ADDENDUM NO. 1

Town of Voluntown Public Works Garage

ADDENDUM ISSUED: May 4, 2018

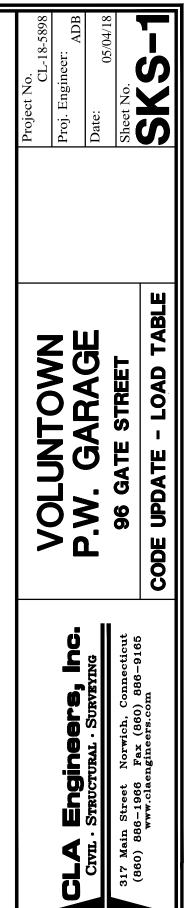
- 7) Contract Documents: Contract Drawings; Sheet S-4; The load table on Sheet S-4 shall be replaced with the attached sketch SKS-1.
- 8) Contract Documents: Contract Drawings; Sheet P-2; The attached Plumbing Fixture Schedule shall be added to Sheet P-2.

- 16) The codes given on the structural drawings are not current codes for CT. I assume to use the 2016 CT State Building Codes? Please confirm. **The new building code is to be used. Refer to Addendum item 7 above for the adjusted load table.**

DESIGN LO	ADS TA	ABLE			
FLOOR LIVE LOADS					
OCCUPANCY OR USE		CONCENTRATED			
COMMERCIAL SLAB-ON-GRADE	125	N/A			
MEZZANINE LEVEL	125	1000			
ROOF LIVE LOA	DS (SNO	W)			
GROUND SNOW LOAD (Pg)	30	PSF			
FLAT ROOF SNOW LOAD (Pf)	30	P9F			
SNOW EXPOSURE FACTOR (Ce)	e	2.9			
IMPORTANCE FACTOR (15)	1.	Ø			
THERMAL FACTOR (Ct)	1.	Ø			
WIND LOADS					
BASIC WIND SPEED (3-SEC)	135 MPH				
RISK CATEGORY		11			
WIND EXPOSURE	1	3			
INTERNAL PRESSURE COEFFICIENT	+/-	0.18			
COMPONENTS & CLADDING	PER ASCE 7-10 (CHAPTER 30)				
SEISMIC (EARTHQU,	BEISMIC (EARTHQUAKE) LOADS				
IMPORTANCE FACTOR (Ie)	1.	Ø			
MAPPED SPECTRAL RESPONSE ACCELERATION					
Se Si		68 260			
SITE CLASSIFICATION	1	>			
SPECTRAL RESPONSE COEFFICIENT					
Sds Sdl		179 296			
SEISMIC DESIGN CATEGORY	1	3			
BASIC SEISMIC FORCE RESISTING SYSTEM		RDINARY FRAMES			
DESIGN BASE SHEAR	6.	ØK			
SEISMIC RESPONSE COEFFICIENT (C6)	0.0	044
